# UNITED STATES PATENT AND TRADEMARK OFFICE

APPLICATION NO.	FILING DATE	FIRST NAMED INVENTOR	ATTORNEY DOCKET NO.	CONFIRMATION NO.
10/009,012	03/19/2002	Henry A. Hill	09712-110001	2161

## Office Action Summary

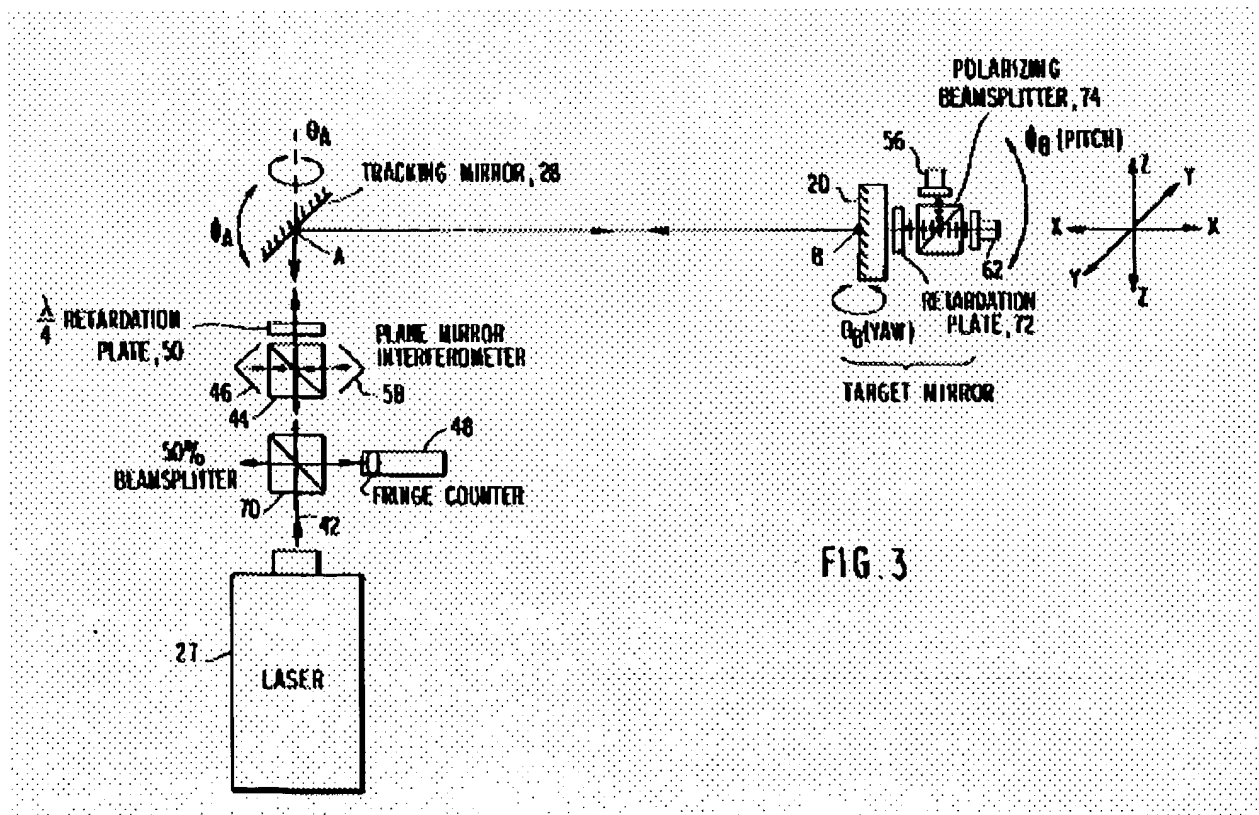
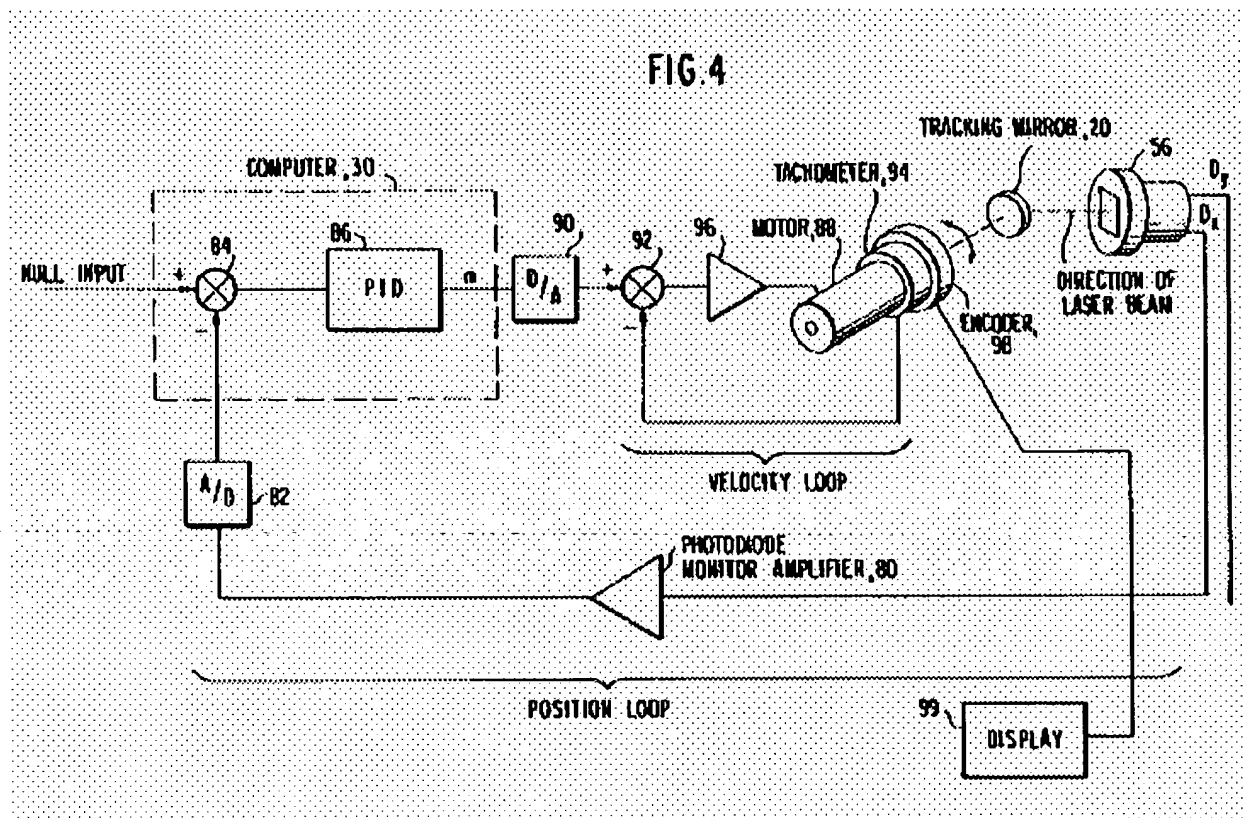
Lau et al teach an interferometer laser tracking system comprising a laser source(27), beam-splitter(70), fringe counter(48), plane mirror interferometer(44,46,50,58), beam steering mirror(28), and target mirror(20). See figure 3. The tracking mirror is controlled by a quad detector, not shown, to maintain the measurement beam on the target mirror and thus measure distance to the target mirror. The target mirror(20) is maintained normal to the measurement beam from the interferometer by a control system which includes detector(56). See figure 4.
